ADDENDA # 2

DEEP CREEK COMMUNITY CENTER

COLUMBIA COUNTY BOARD OF COMMISSIONERS (CCBC)

November 14, 2014

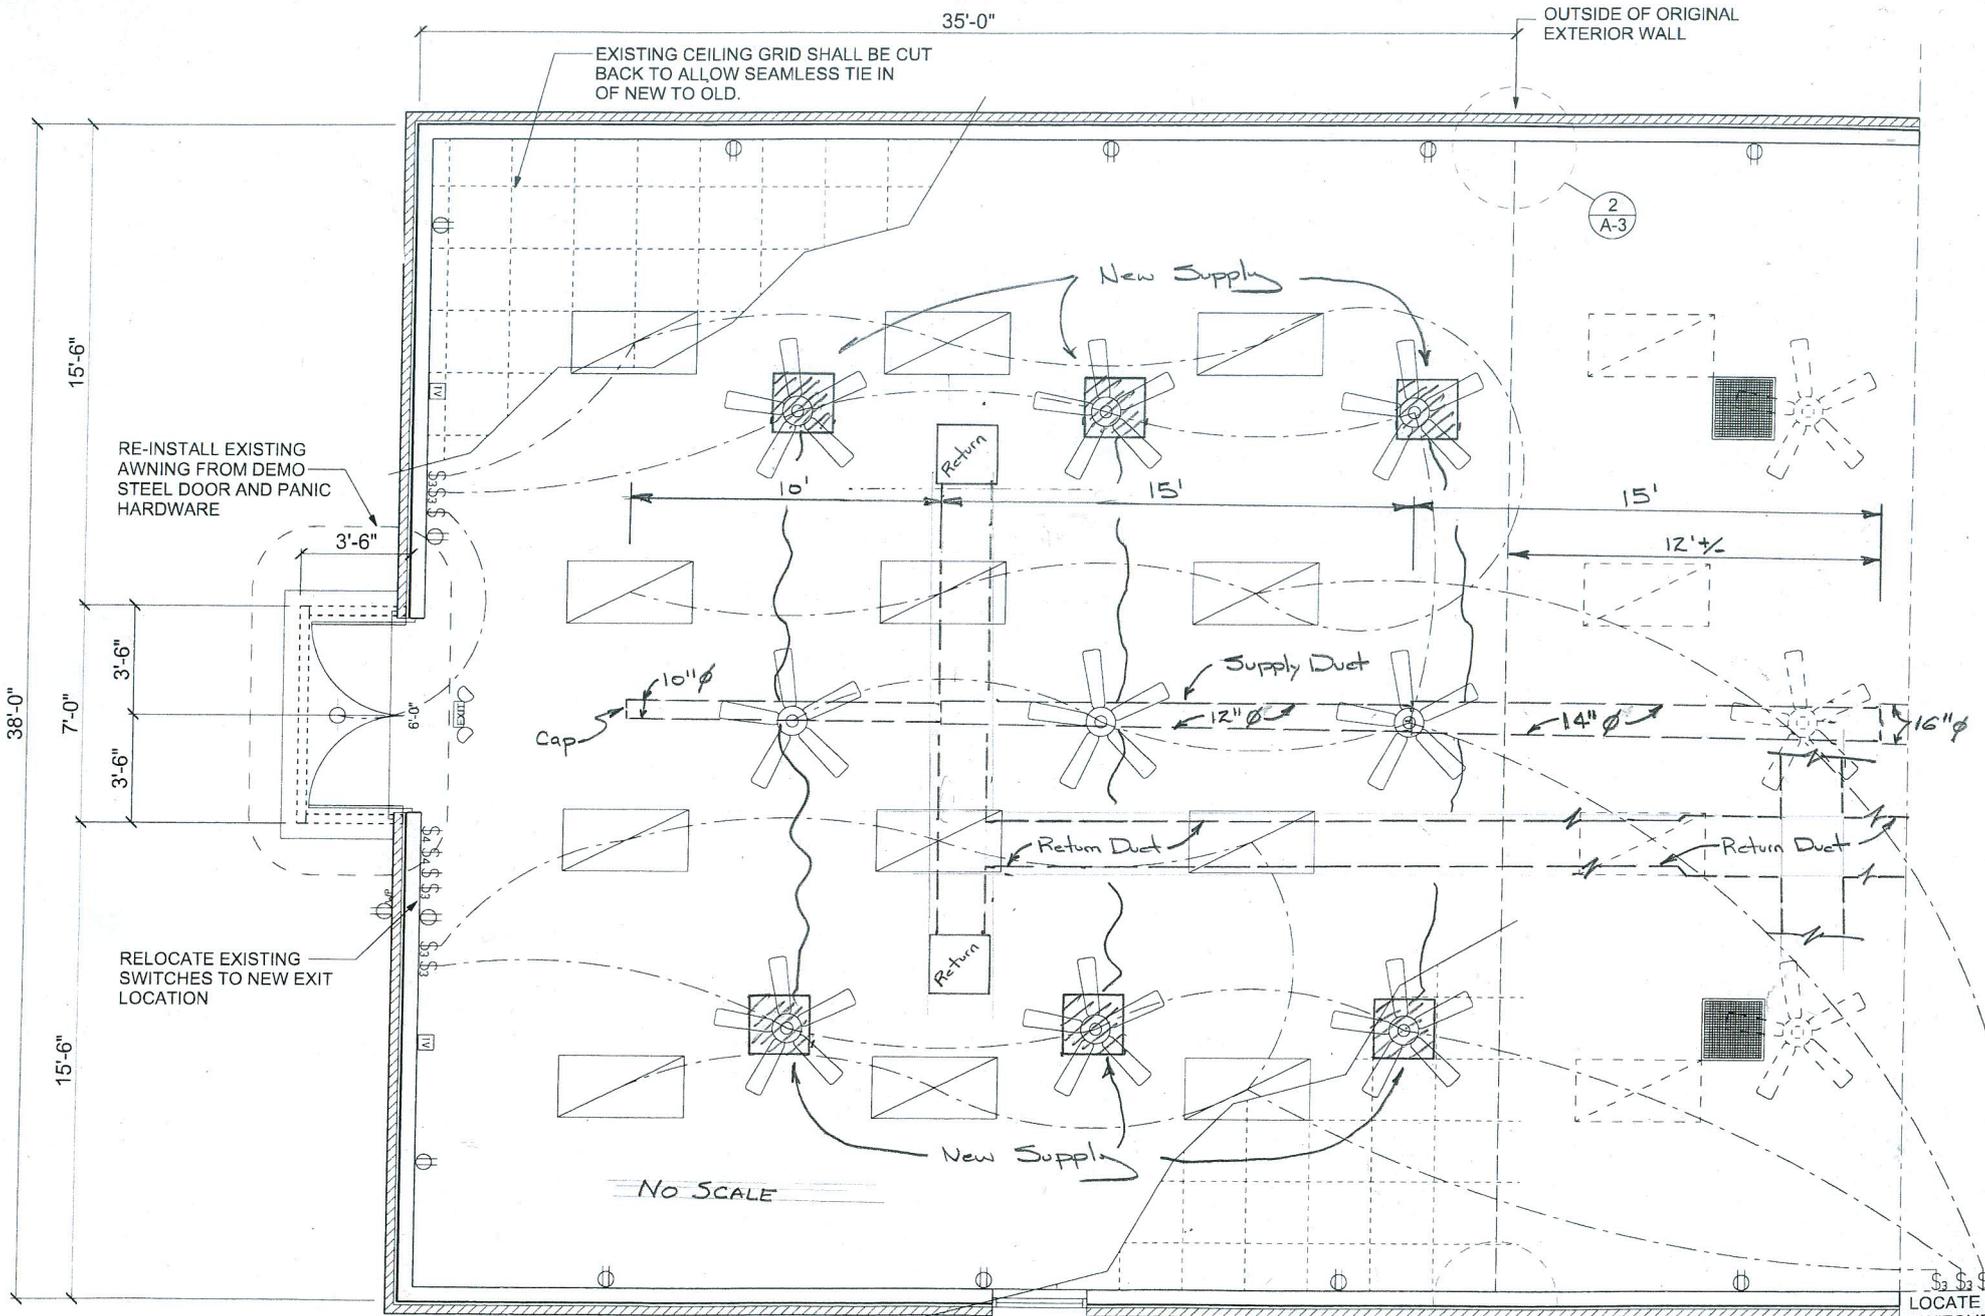
- Provide new supply and return trunk lines as per attached drawing. Remove existing return tee. Construct and install 4-way distribution box using 1" ductboard and attach to existing return ducts. Continue return duct using next size smaller to a location at the middle of the new addition. Construct and install new tee distribution box and run return duct to two (2) locations as per the attached drawing.
